RE: Request for Contested Case Hearing – WQ 0002927000
TCEQ Commissioners Meeting – January 24, 2024

Purpose of this letter – Reaffirm My request for a contested case hearing on the proposed permit WQ 0002927000.

Applicant for the permit – Lyondell Chemical Corporation
2502 Sheldon Road, Channelview, Texas 77530

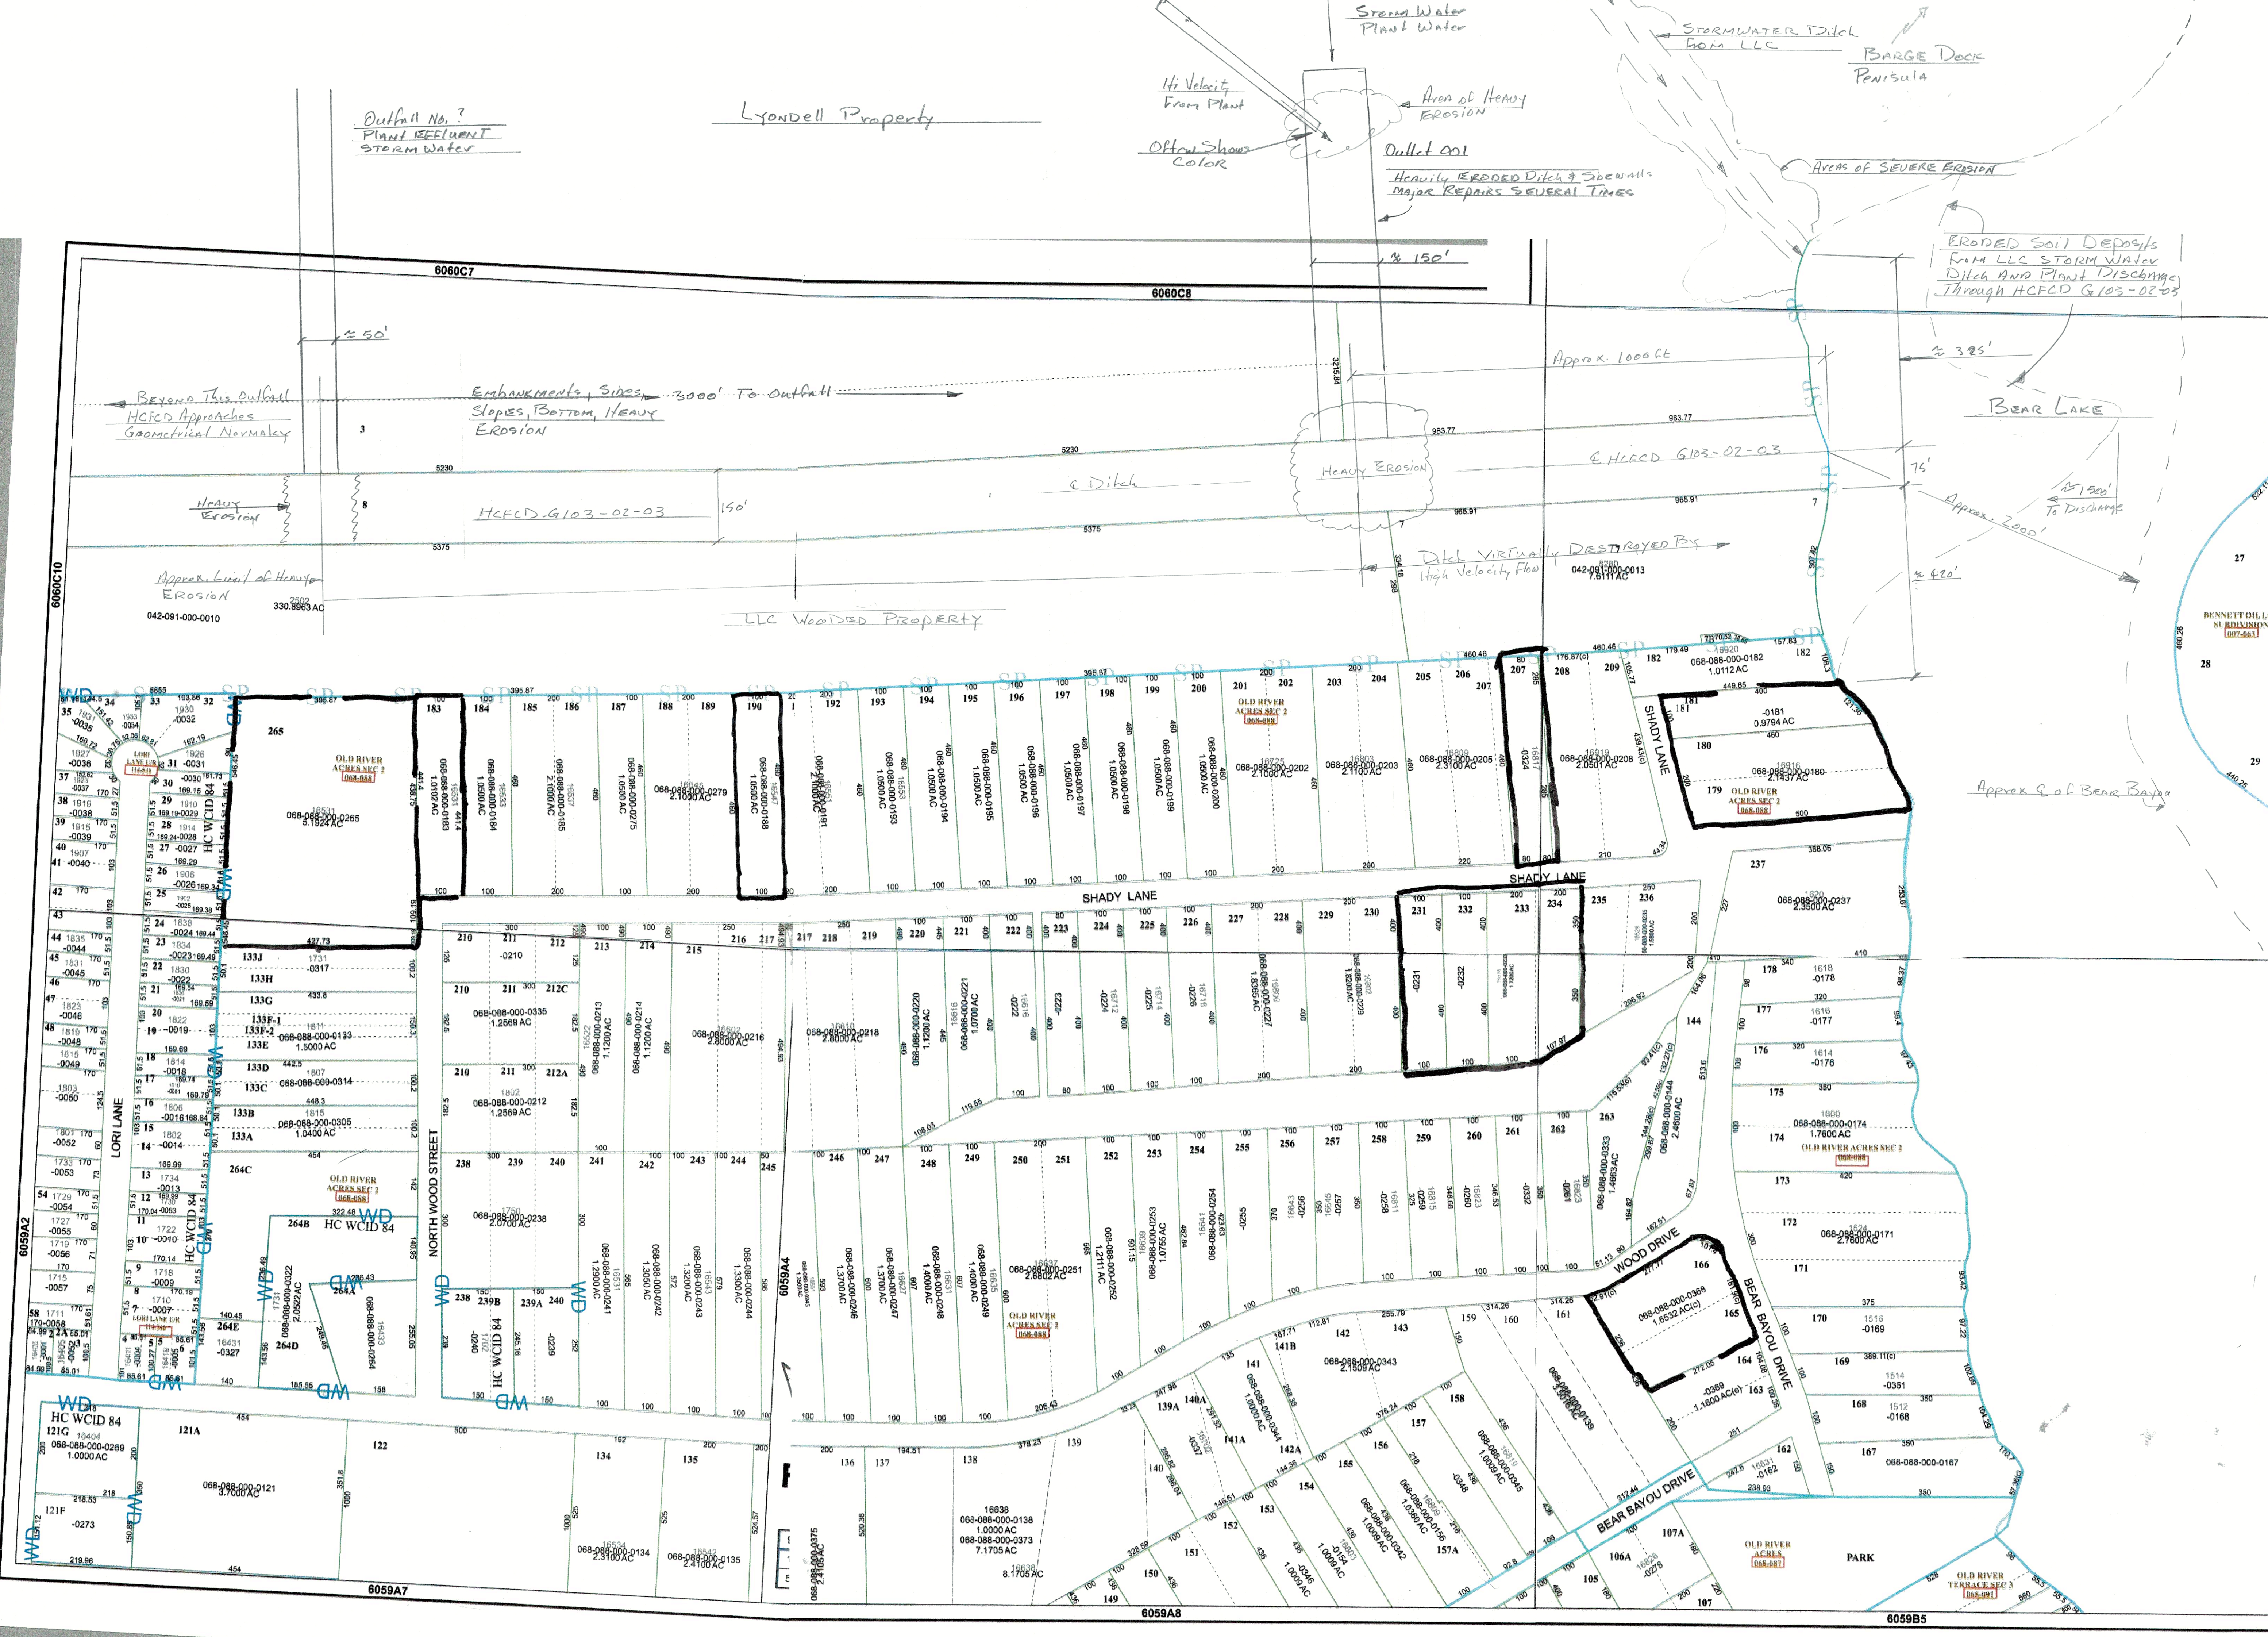
Property Map – This map will demonstrate the following: (comments are approximate)

- The properties owned or mortgaged by myself and the distances of these properties from the Harris County Flood Control Ditch used as the main channel for plant effluent discharges. My homestead is located approximately 450' from the centerline of the discharge point for G103-02-03 into Bear Lake.

- The main discharge route for stormwater runoff from the plant facility. The discharge into Bear Lake is located approximately 350' from the main discharge from G103-02-03.

- The location of the main plant discharge of effluent is shown as outfall 001 on the map.
- The approximate location of the center line of Bear Bayou is shown.

- The approximate location of a high velocity discharge pipe that empties into outfall 001.
- The locations and areas of G103-02-03 which are heavily eroded.

- The location of the main stormwater discharge ditch that is heavily eroded.
- The length of G103-02-03 which is heavily eroded and the remaining part of G103-03-02 which appears to be operating as designed.

- The approximate length of eroded soil and plant effluent that have been deposited into Bear Bayou Lake by the discharges of G103-02-03 and the main stormwater discharge ditch.
